CPP Project 7530

Subject: Reflectivity and Wind Engineering – Frasers Blocks 1 and 4N

The purpose of this report is to outline the changes to the wind environment around the site and reflectivity, due to the proposed revised massing and geometry of Frasers Blocks 1 and 4N. This report covers both the S75W Amendment to Blocks 1+4N, and State Significant Development Application for Block 1. The global wind conditions around the site are governed by more than the geometry of a single building, hence why the changes to these large adjacent buildings have been grouped together in a single report for the approvals process.

Figure 2: Results from previous wind tunnel testing

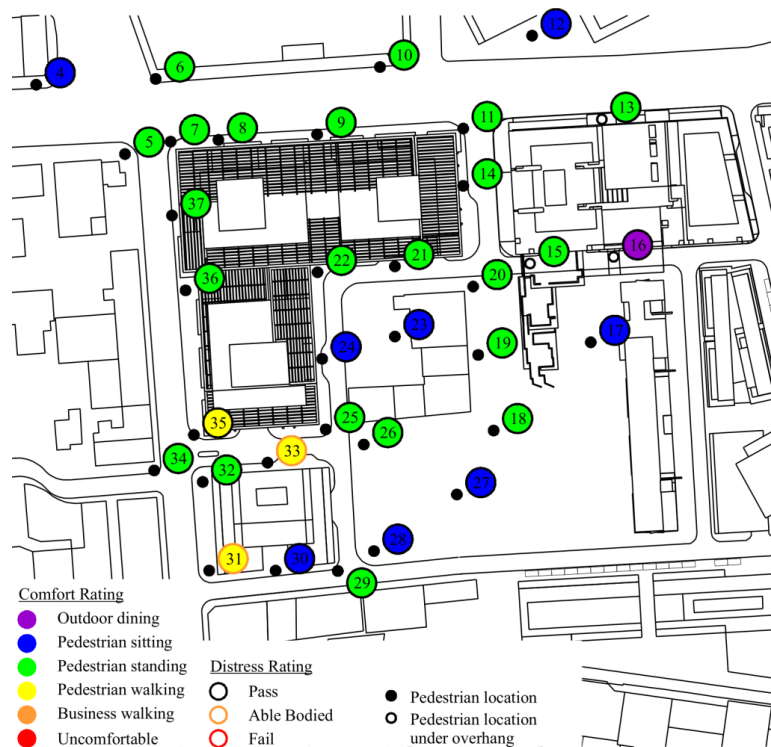
Wind-tunnel testing has not been conducted on the proposed building layout as the building layout is considered similar enough to allow a qualitative assessment of the wind conditions in the public domain to be extrapolated from the existing results. The relevant wind tunnel testing was conducted on the original Frasers Broadway design layout and reported in CPP report 4946 entitled '*Frasers Broadway Blocks 1, 4, and 8*' dated May 2009. The results from the previous testing are presented herein to frame the qualitative discussion on the wind conditions in and around the public domain for the proposed changes, Figure 1. A photograph of the wind tunnel model from is presented in Figure 1. The primary results reproduced in Figure 2 show that the pedestrian areas around the Blocks of interest are generally acceptable for use as public standing from a comfort perspective, such as window shopping, and pass the distress criterion.
